Southern Nuclear Operating Company  
Vogtle Electric Generating Plant Units 3 and 4  
Request for License Amendment and Exemption:  
Containment Hydrogen Igniter Changes (LAR-15-003)

**Southern Nuclear Operating Company  
Vogtle Electric Generating Plant Units 3 and 4**

**Request for License Amendment  
Containment Hydrogen Igniter Changes  
(LAR-15-003)**

Table 6.2.4-3  
Component Data - Hydrogen Igniter  
(Nominal)

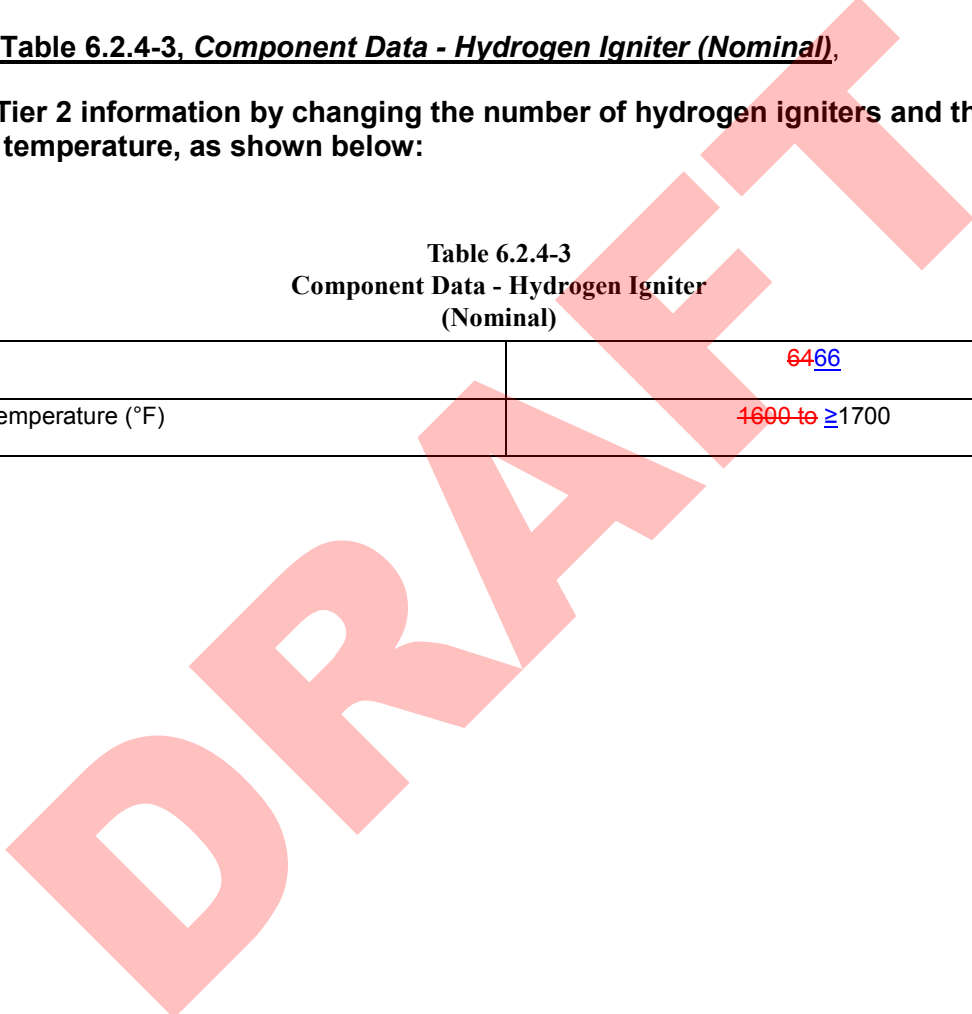
- Tier 2 Table 6.2.4-3, Component Data - Hydrogen Igniter (Nominal), a change is proposed to revise the number of hydrogen igniters to 66.
- Tier 2 Table 6.2.4-6, Subcompartment/Area Igniter Coverage, a change is proposed to revise the IRWST location in the table to eliminate the number of vents fitted with hydrogen igniters to account for more than four vents currently noted.

**Revise Tier 2 information by changing the number of hydrogen igniters and the igniter surface temperature, as shown below:**

Number	<del>64</del> <u>66</u>
Surface Temperature (°F)	<del>1600 to</del> <u>≥1700</u>
